BID #24-26-D04
Sitework and Structural for Downtown Campus
Addendum One
Released 11/26/2024

ADDENDUM: Addendum One addresses a process to request to be added to a prime/sub list for this project, questions and clarifications, a revised bid form, and drawings for DLC and DTC.

**Rock Valley College
New Downtown Campus
Sitework and Structural
Bid #24-26-D04**

Architect's Project Number: 23-030

2 SUSPENDED LINTEL AT ROOF - MID DEPTH
 1 1/2" x 1 1/2"

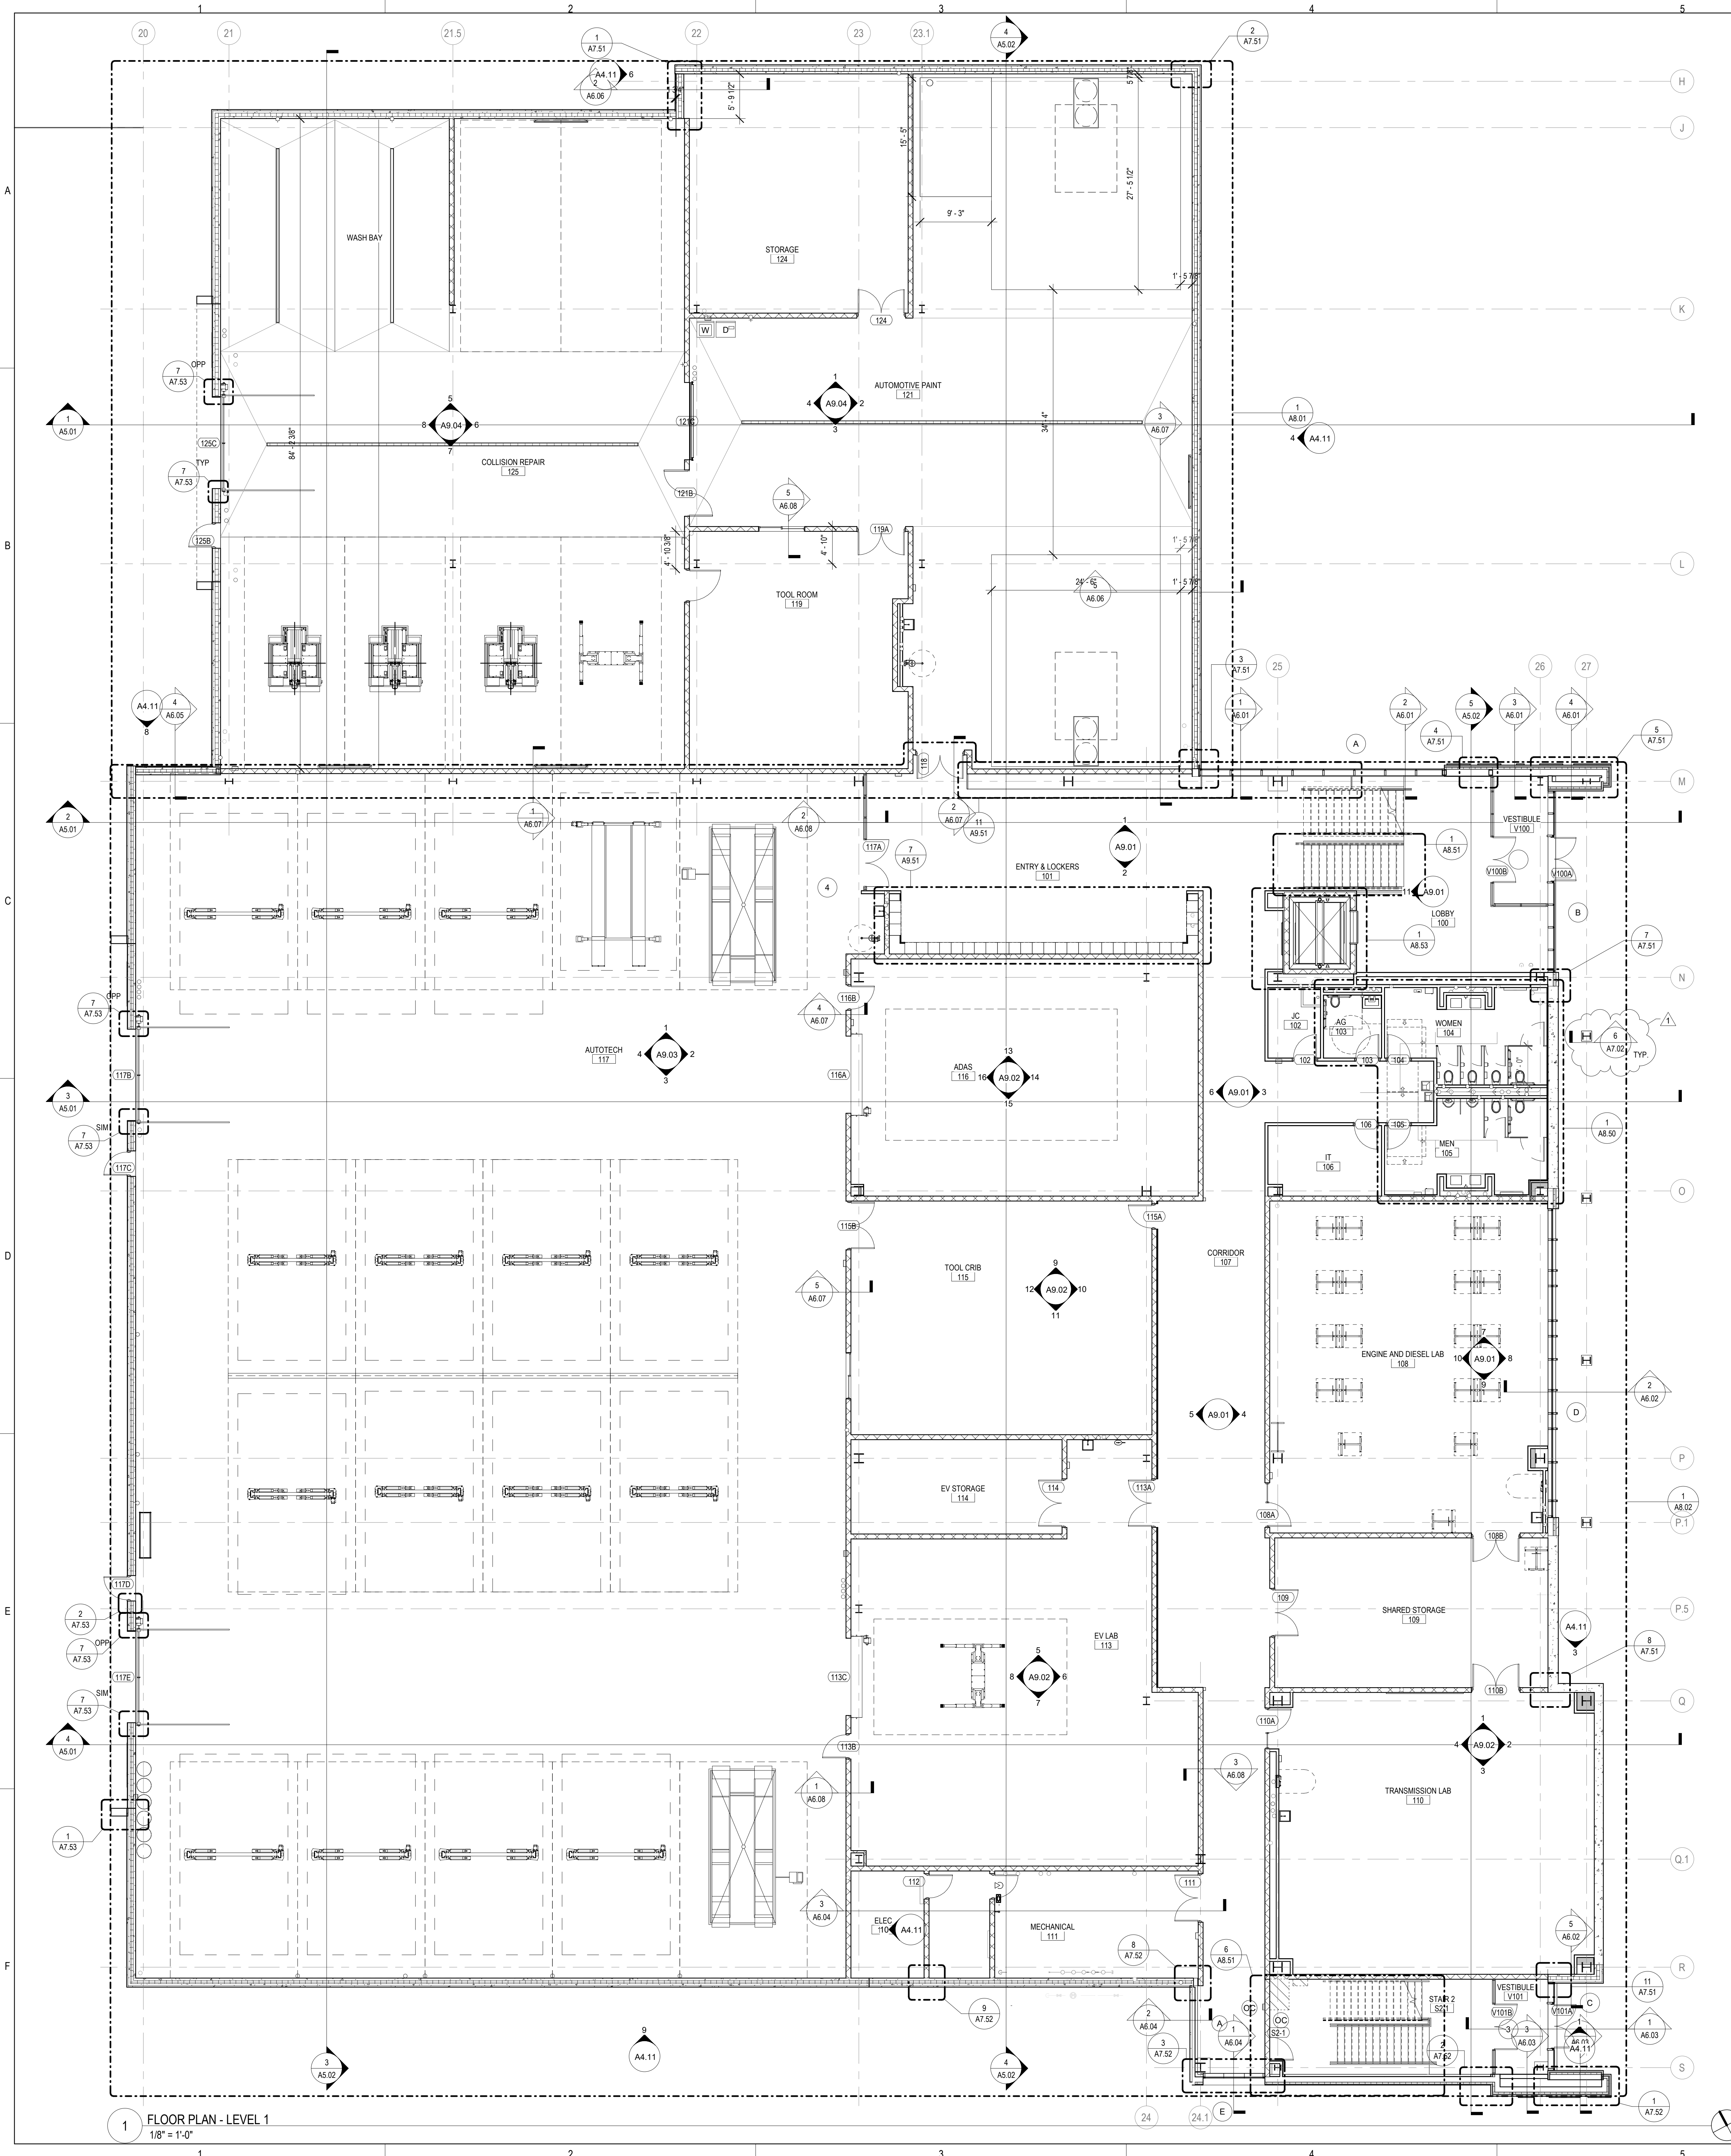
- B. Detail 6 updated to fit deeper brick dimensions below floor deck.
 - C. Details 10 and 11 added, see notes on plan sheets.
22. Sheet S3.12
 - A. Detail sheet added

SHEET NUMBER:
S1.00

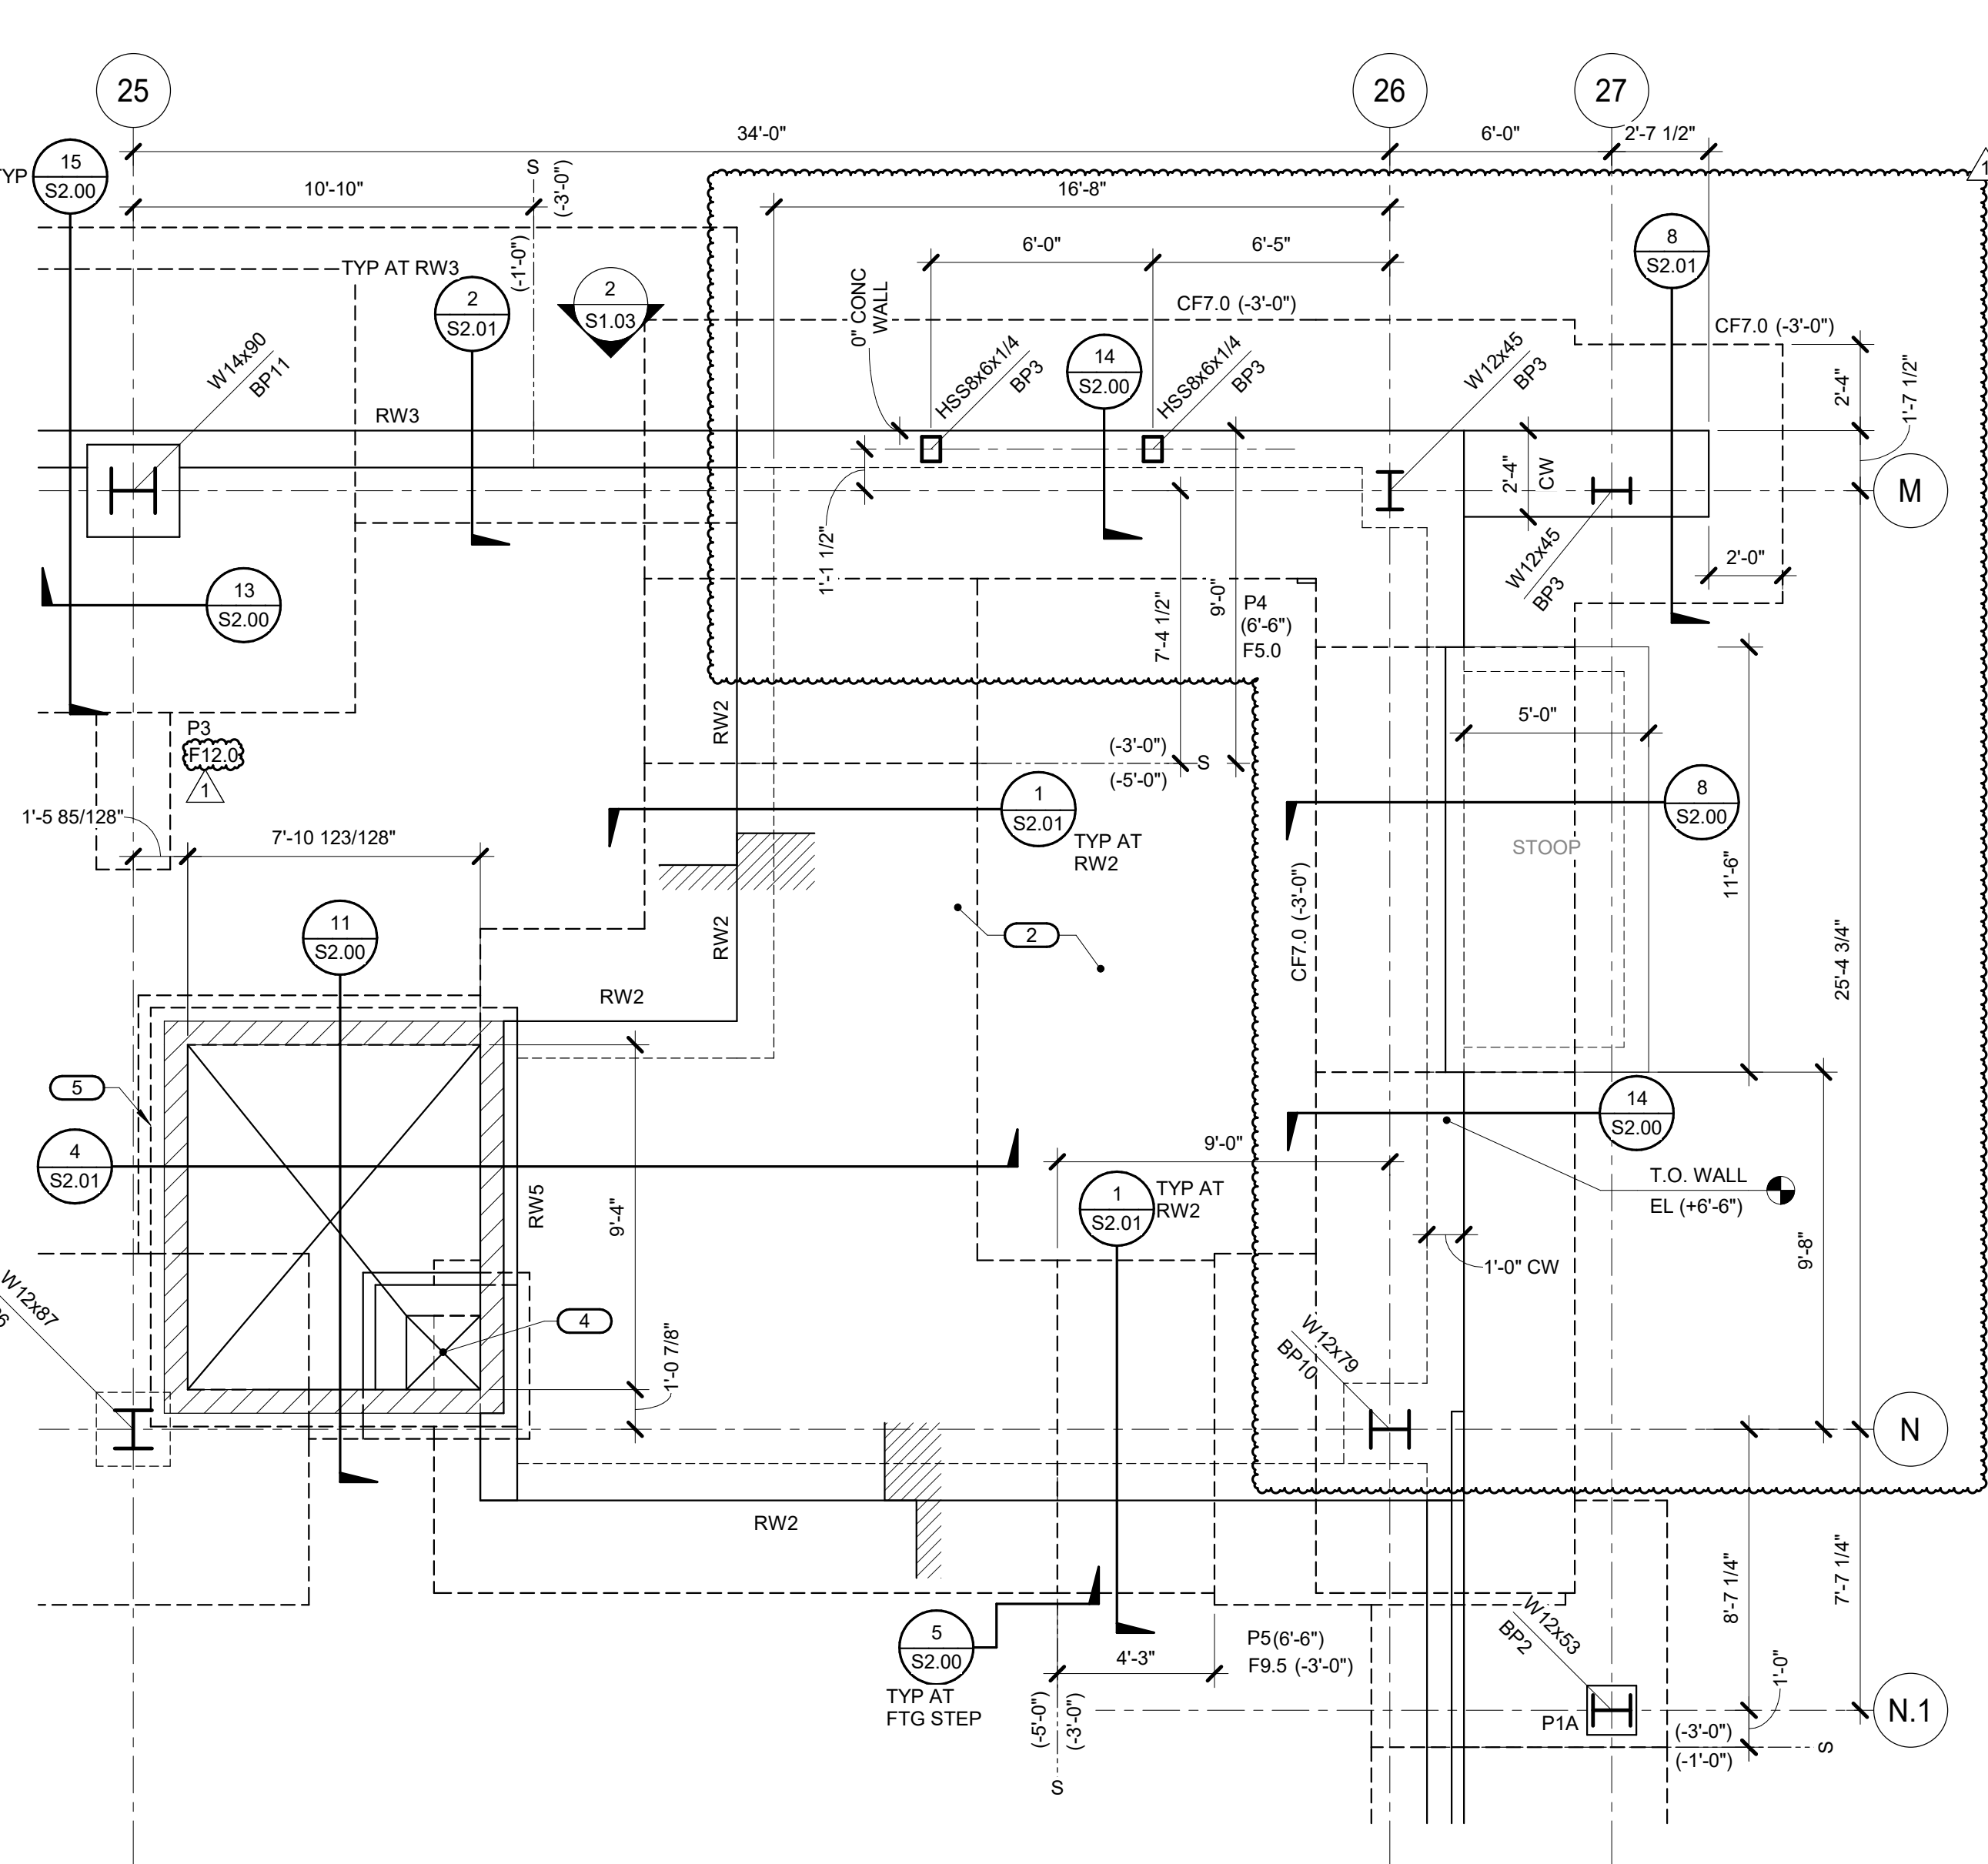
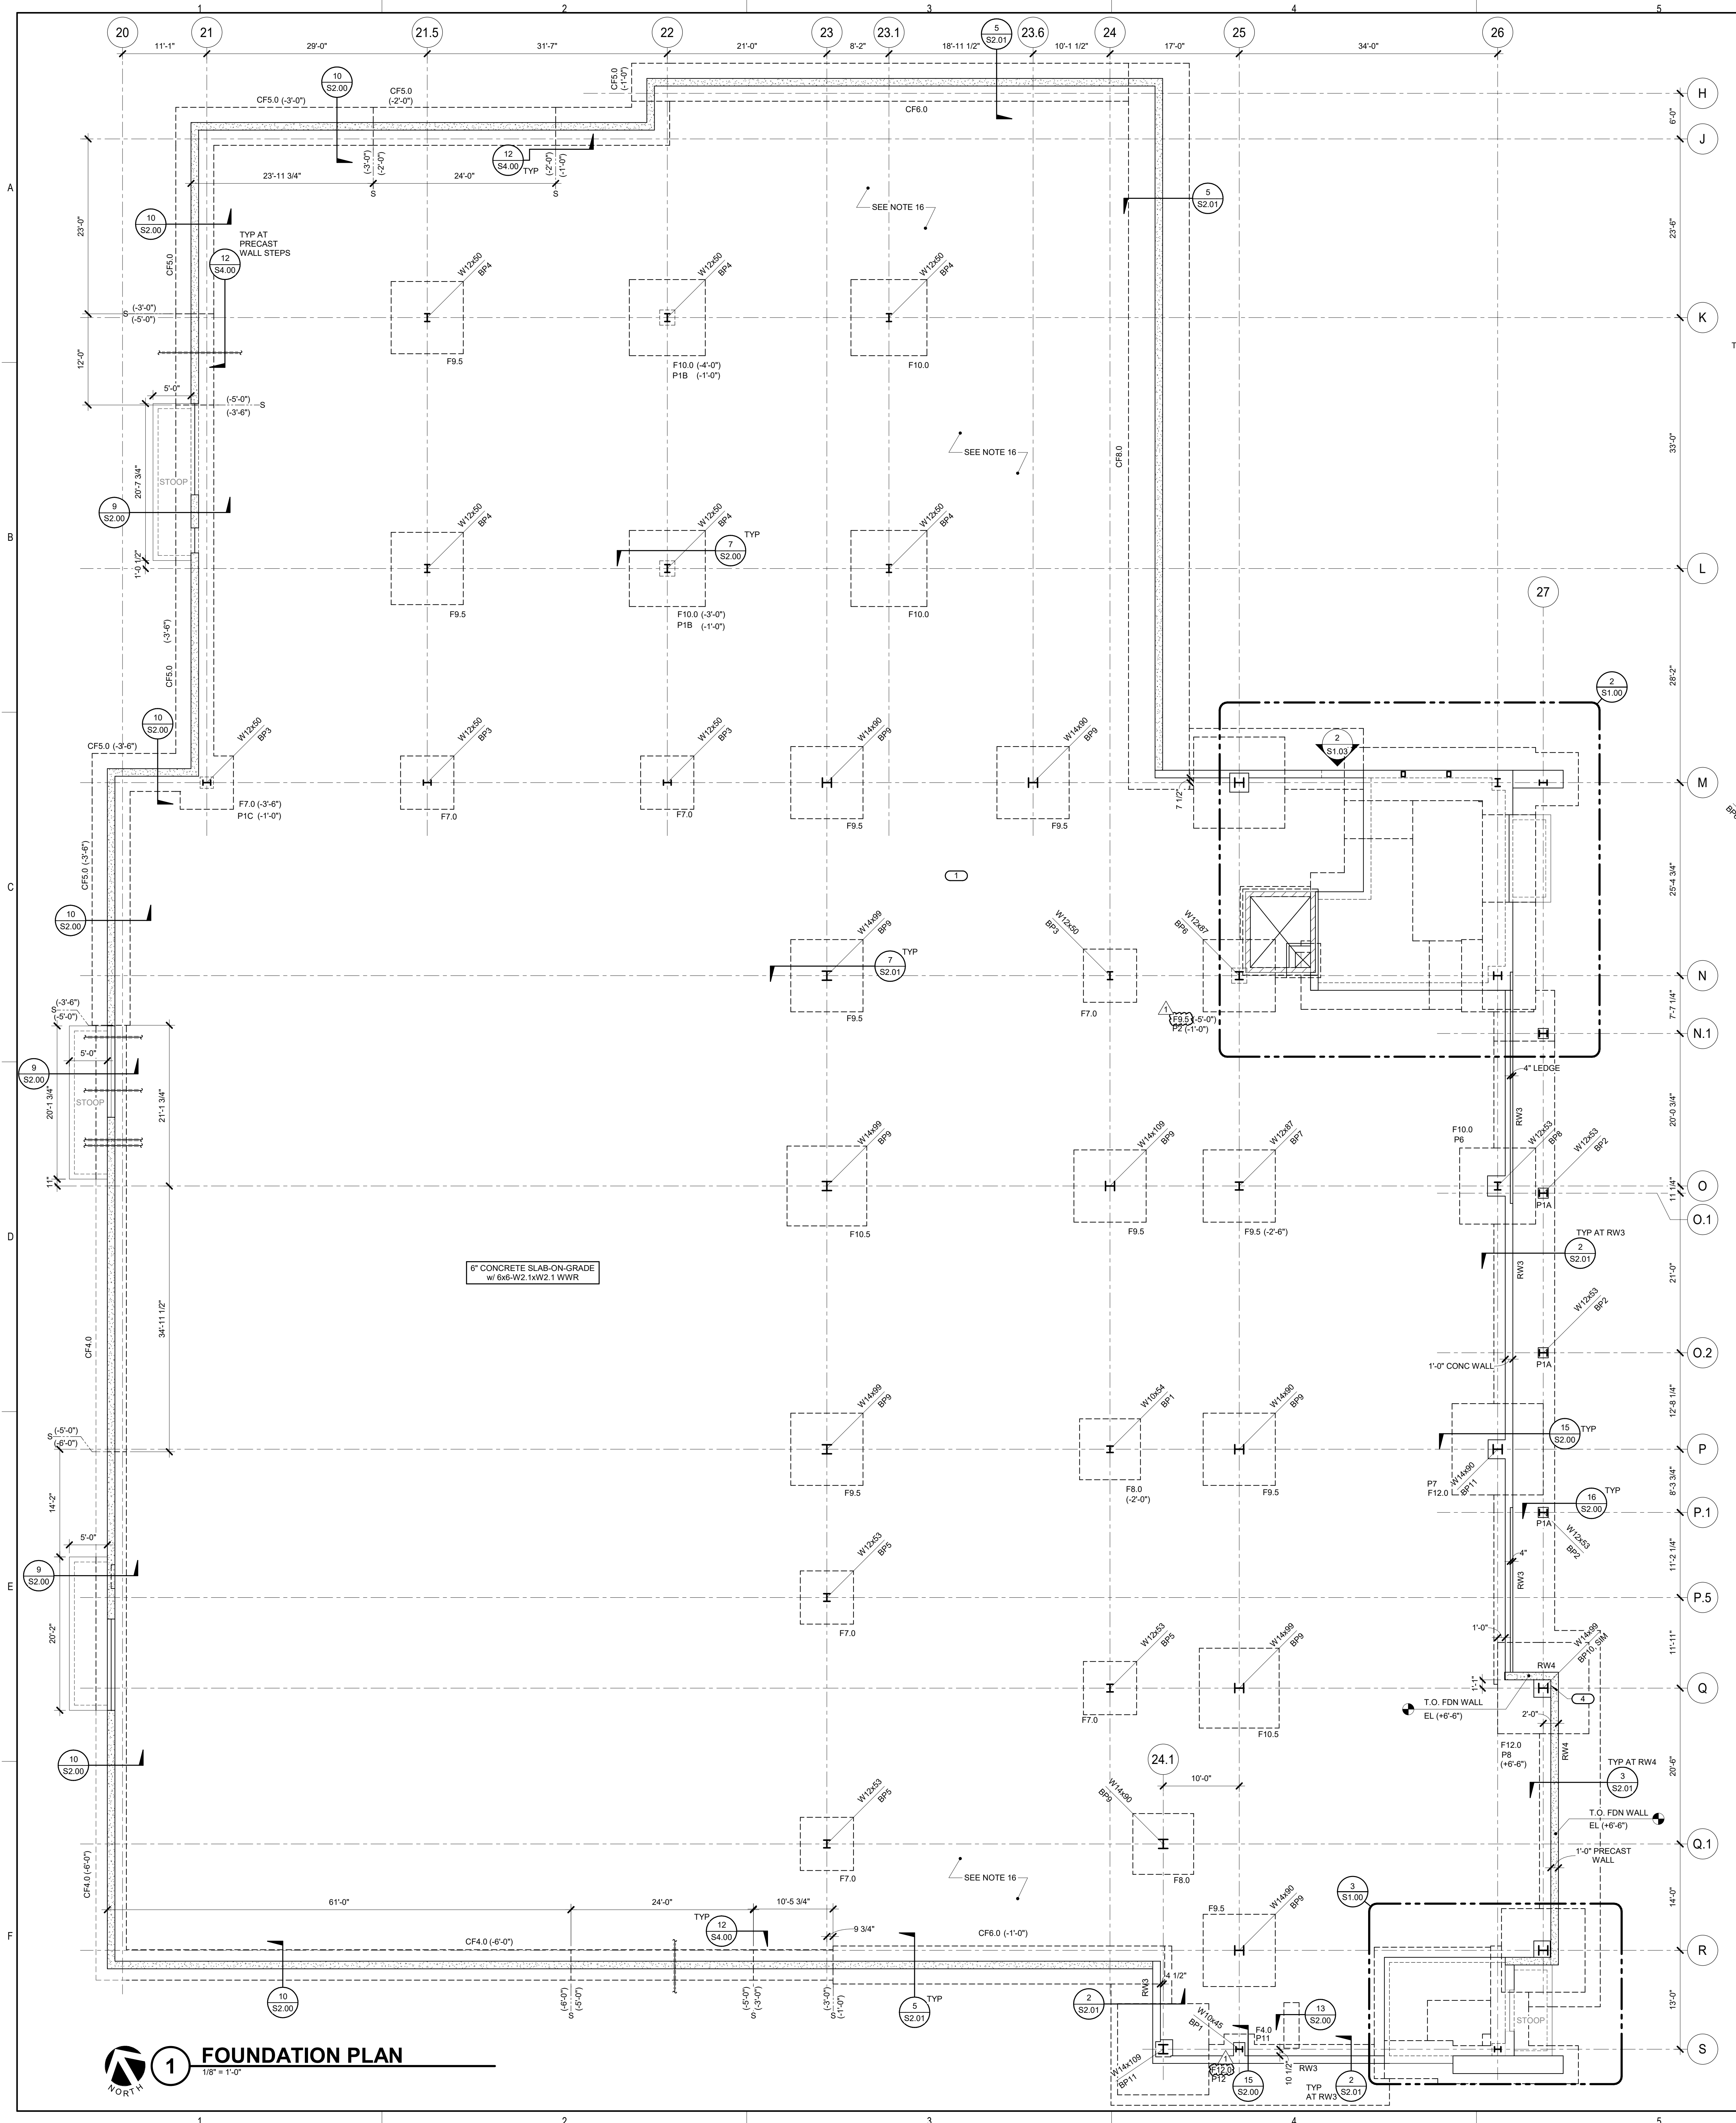
- B. Post-Installed Anchors updated to Hilti products.
8. Sheet S1.00
 - A. Retaining wall foundations updated as required for coordination between slab and stem wall.

- B. Details added at oversized feature walls at Grid M and Grid S.
9. Sheet S1.01
 - A. Detail cut added at edge of deck along Grid 25.
 - B. Details updated at wind girt across EV Lab – detail 14/S4.01 along Grid 23.
